DSP-99048/01

STAFF REPORT

SUBJECT: Landy Property
Revision to Detailed Site Plan, DSP-99048/01

FIGURE 1.

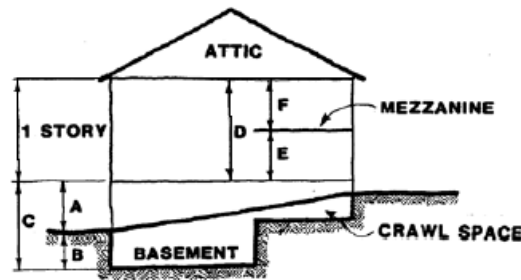
"Figure 1 of the Zoning Ordinance, as shown above, depicts a situation identical to what is proposed on the sixteenth story of the Landy towers. The main volume proposed is less than 20-ft high (at 18', 8"), and the proposed mezzanine floor area is never more than the required one-third (1/3) of the contiguous, open floor areas to which it is open below. In addition, the 2003 International Building Code (the MD State Building Code) has a strict definition and set of requirements for mezzanines that is consistent with the 1/3 area limitation stated in §27-107.01.(223) of the Prince George's County Zoning Ordinance. In IBC, mezzanines are not considered to be additional floor areas and exterior balconies have no occupancy load for egress purposes. The proposed unit design conforms to 2003 IBC requirements. The additional space proposed on the sixteenth story provides the units with striking, dramatic volumes and mezzanines that permit the owners the luxury of several options for utilizing the space."

Staff comment: Staff agrees with the applicant's legal argument that the use of a mezzanine at the 16th floor does not constitute a "story" per the definition of that term in the Zoning Ordinance. The building will appear to be 17 stories, if one counts the levels of windows on the outside of the building. However, the definition of "story" is difficult to refute, as the Zoning Ordinance is clear. Further, these units fulfill the intent of the requirements of the TDDP in that the sector plan demands that multifamily units developed in the transit district must demonstrate a certain level of luxury. The use of these penthouse units will provide a level of luxury beyond that normally found in multifamily development in the county.
